Summary for DRH12-00013

RIVER EDGE
APARTMENTS
1004 W. ROYAL BOULEVARD, BOISE, IDAHO
TOPOGRAPHY &
PRE-CONSTRUCTION PLAN

Planning Division Staff Report

File Number	DRH12-00013
Applicant	The Michaels Organization
Property Address	1004 W. Royal Boulevard
Public Hearing Date	February 8, 2012
Heard by	Design Review Committee
Analyst	Sarah Schafer

RIVER EDGE
APARTMENTS
1004 W. ROYAL BOULEVARD, BOISE, IDAHO
SITE & DIMENSIONING PLAN

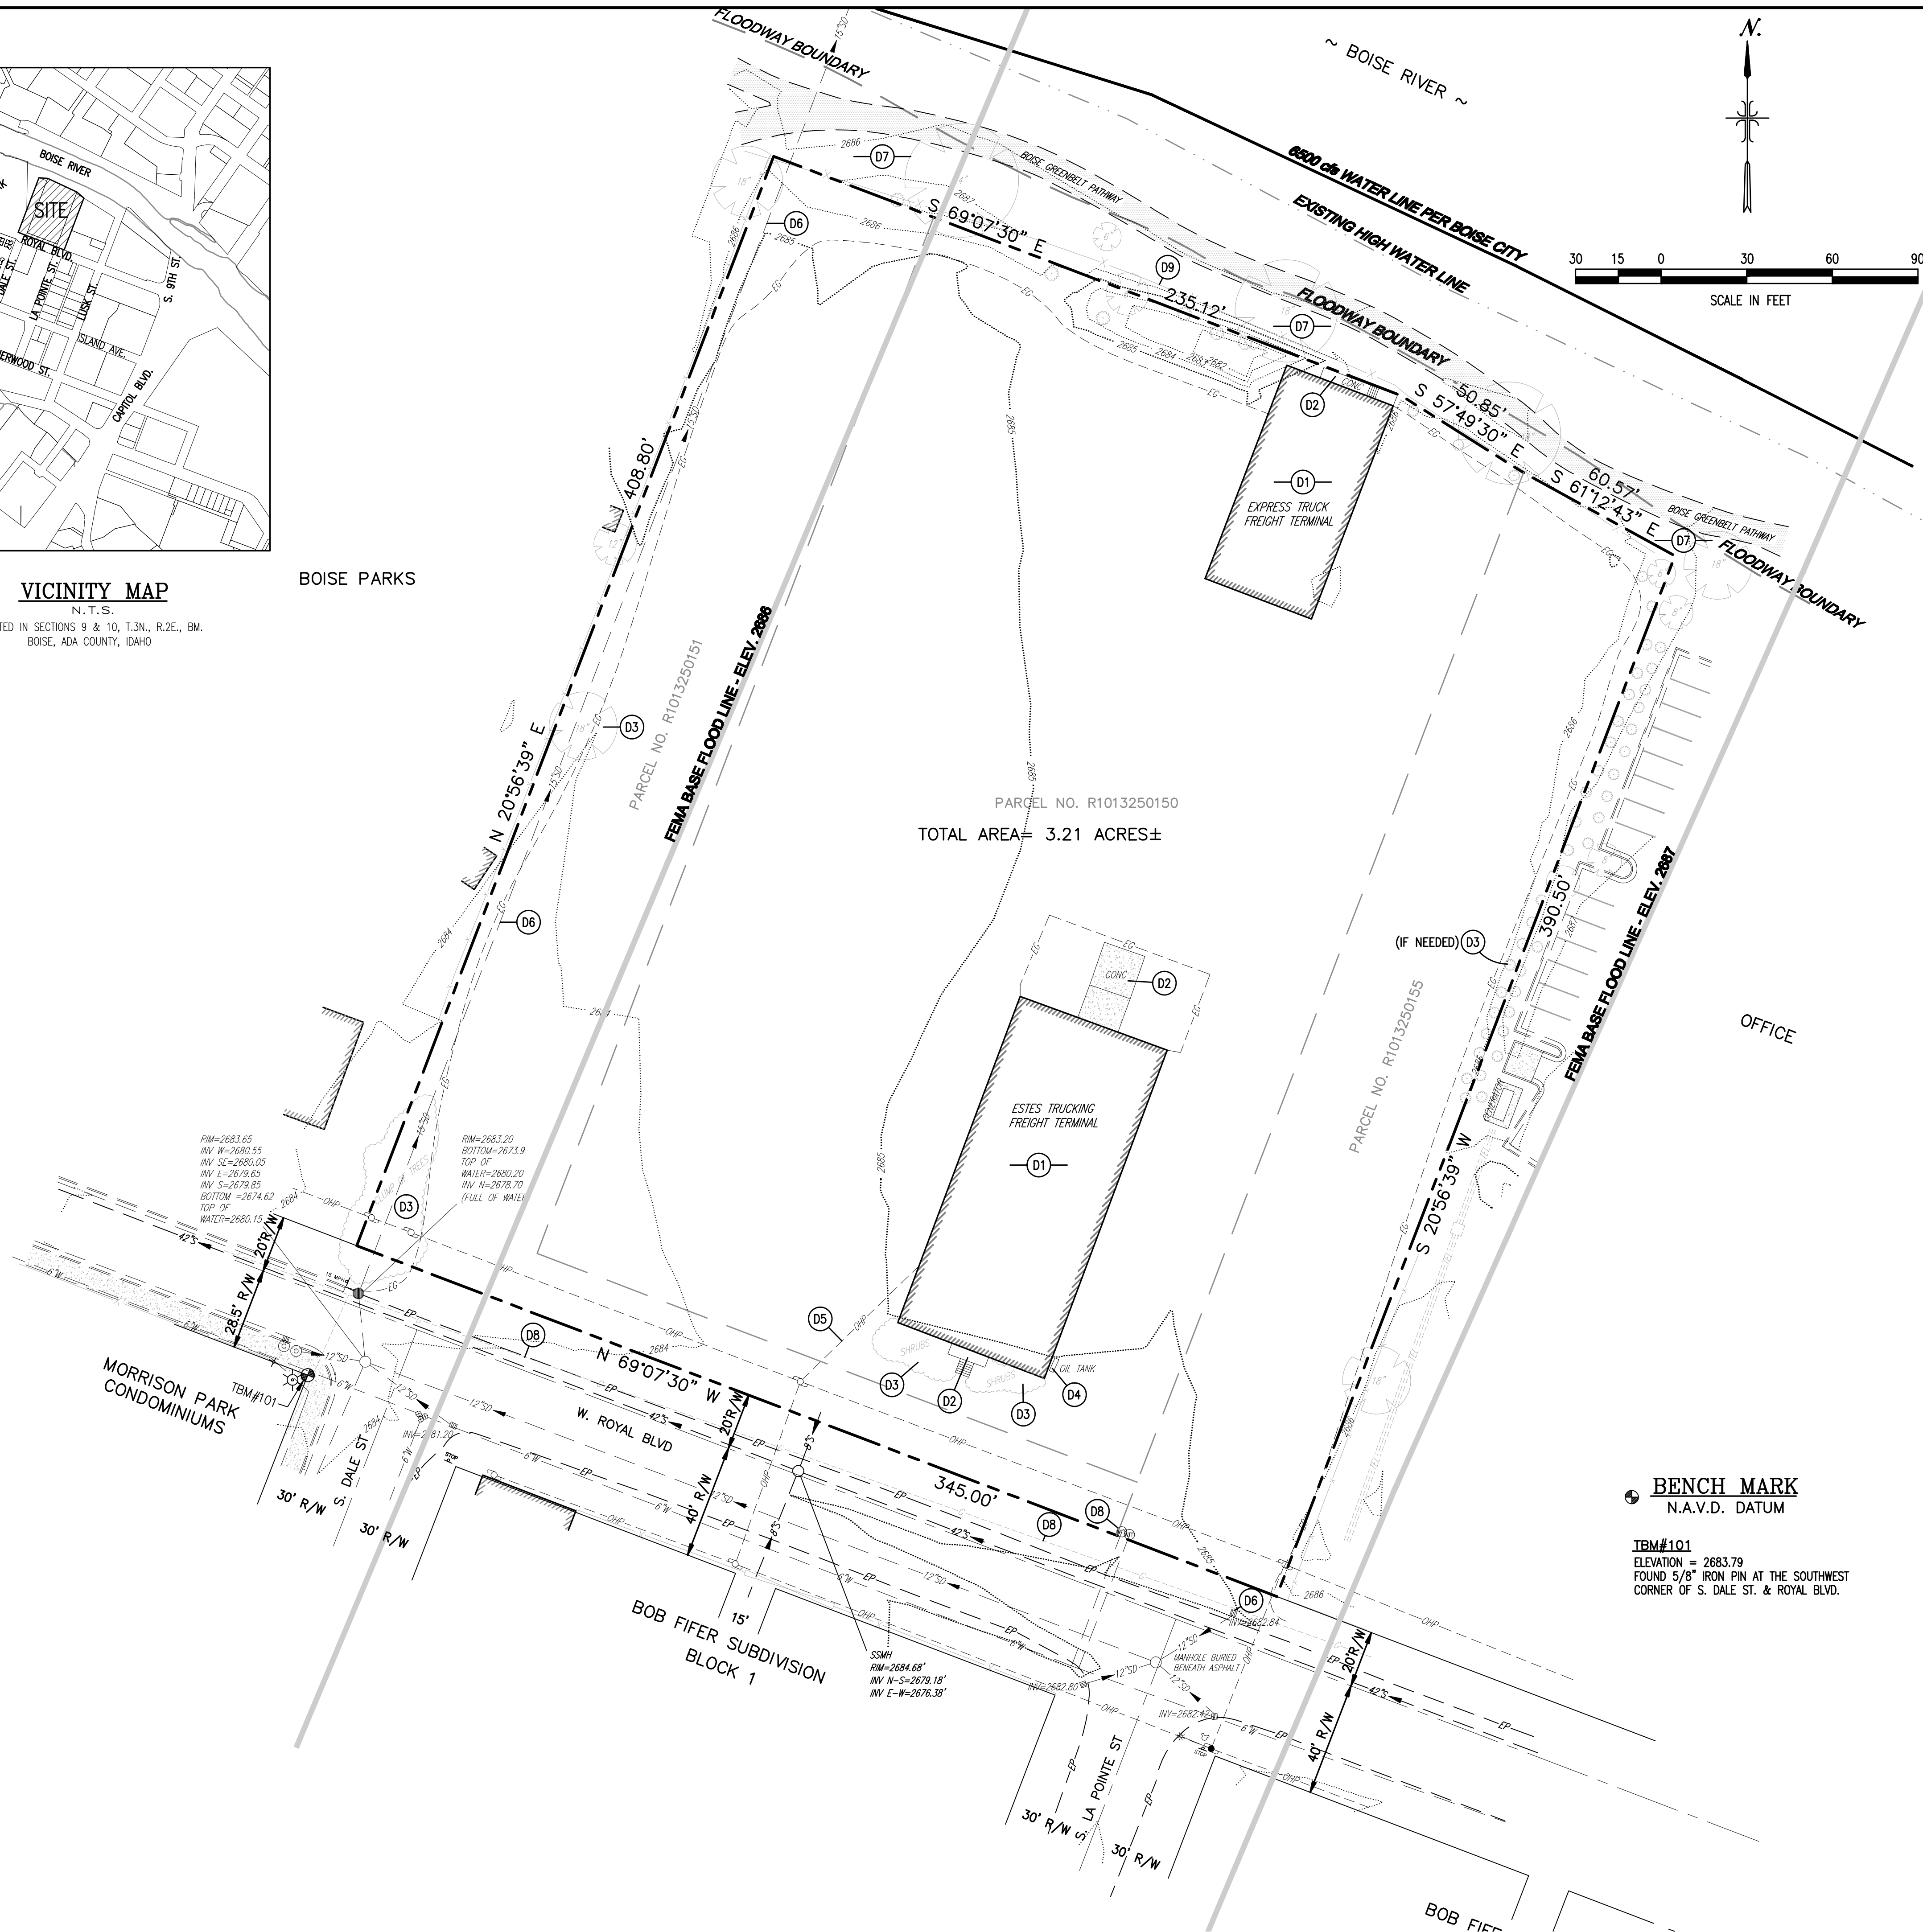
The public sidewalk along Royal Boulevard is detached from the curb eight feet to allow for the installation of street trees. The sidewalk is proposed at six feet wide, it should be increased to eight feet in order to accommodate the high amount of foot traffic in the area for entry into the adjoining park as well as those accessing the Greenbelt. This is the same standard along Royal Boulevard required for the Royal Cubes application directly to the south of this project. A sidewalk should also be added from the door exiting the stair tower to the west of the main entry to the public sidewalk.

There are a couple conditions of approval which will affect the landscape plan such as moving of the transformers on the southwest corner of the site, the addition of some pavement in order to accommodate for turnaround of vehicles at the garage entry and the addition of sidewalk from the northeast and southwest stair towers. Staff believes these items can all be easily accommodated without harming the integrity of the design intent.

There are three transformers located on the southwest corner of the site. They are currently within 5 – 6 feet of the front property line and only a foot off of the side property line. With the property to the west being Boise City Parks land, there is little concern about the adjacency to the west property line however, staff would like to see the transformers set off of the front property line by the required ten feet. This will help with clear sight lines in exiting the parking area. Since this is a major entry point into the park, keeping the sight lines open is important.

- c. The transformers at the southwest corner of the site shall be set at the 10' setback line.
- d. Provide a 10' setback from Royal Street for the open-air parking.

- i. A sidewalk from the exit of the stair tower located to the west of the main entry shall be constructed to the public sidewalk.
- j. The site plan shall show the location of the entry pad location for accessing the structured parking area.

- k. On the east elevation, after the open-air parking stalls where the drive aisle becomes one-way, a small amount of additional paving shall be added to allow for vehicles to turn around who can't get through the garage gate.

FIRST FLOOR PLAN

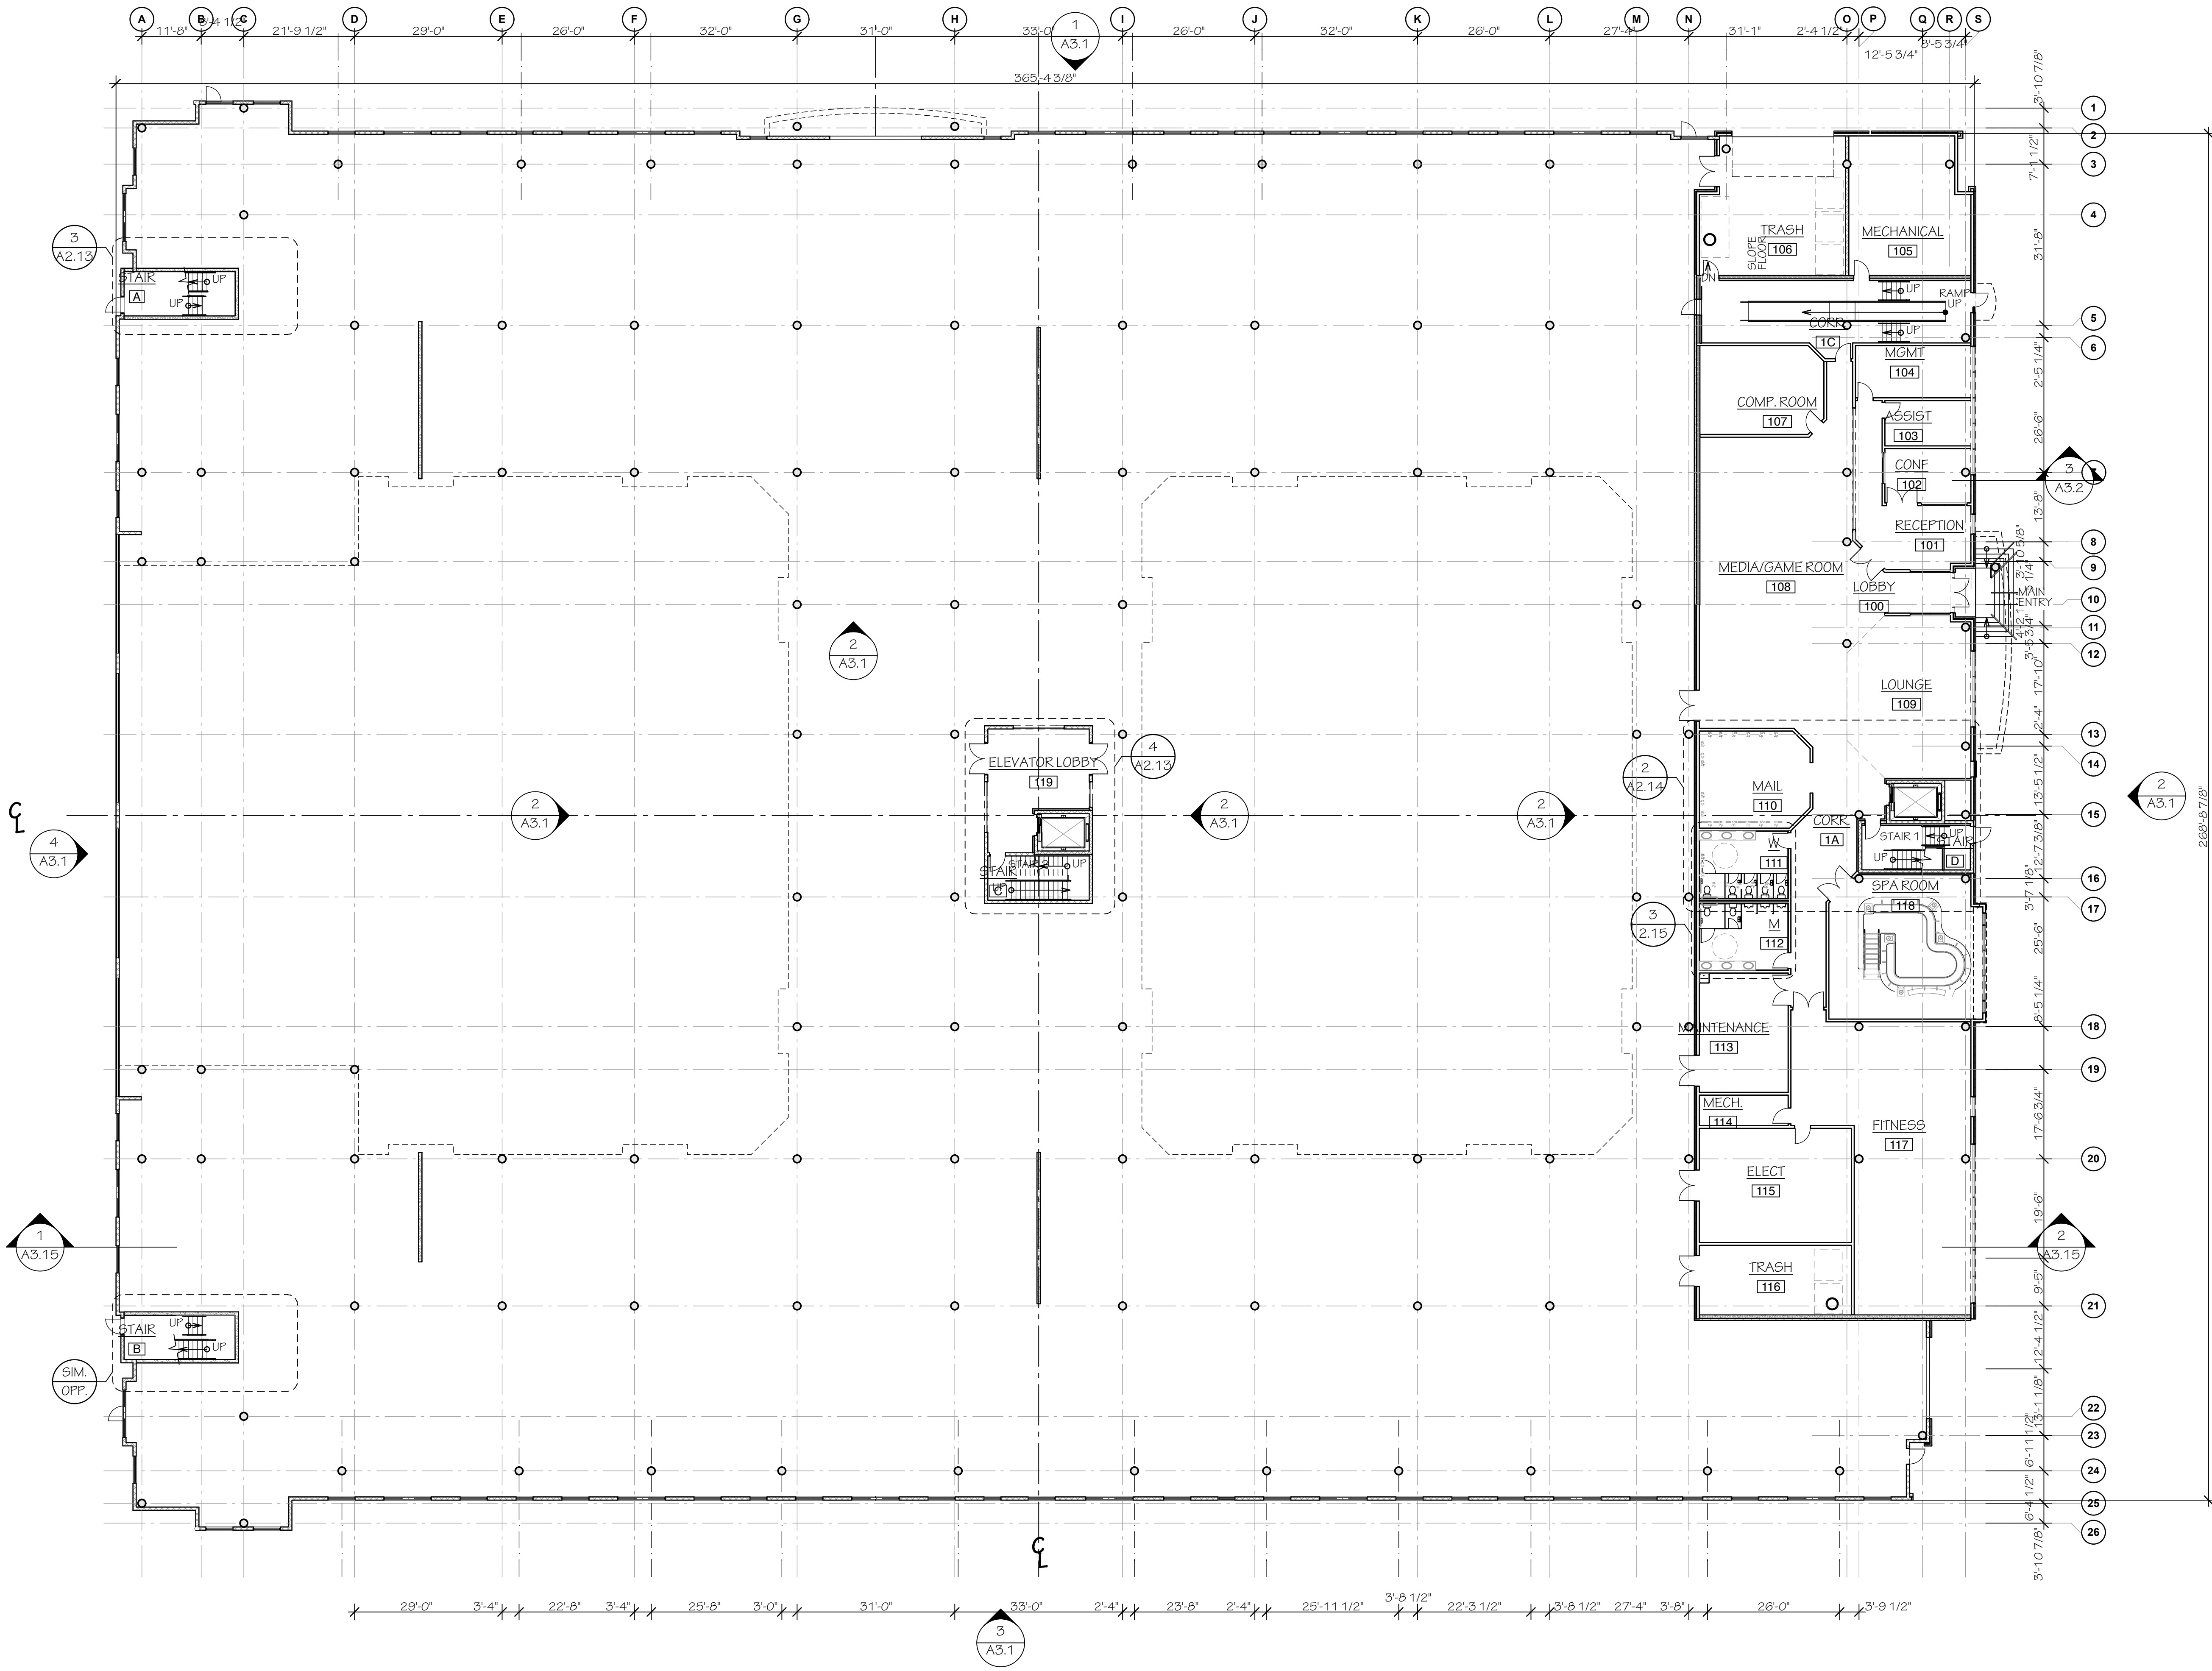
There is some concern with the design interest of the first level. The front wall plane does have windows with canopies over them however the canopies over the windows are approximately two feet in depth. Given the south portion of the first floor is office space and not parking, staff believes it would be appropriate for the wall plane to step similar to the upper levels. Other possible options for adding interest on the south elevations would be the installation of raised planters at the base of the building, trellis, larger canopies, or other non-structural design items could be considered. With the west and east portions of the at grade structure housing parking, it is understandable why those walls are not able to step and maintain functional space.

- q. The door on the stair tower to the west of the main entry shall be glass with canopy to match the door on the east end of the south façade.
- r. Step the south wall plan, similar to the upper levels in order to provide shadow relief and design interest along the most visible portion of the building at street level.
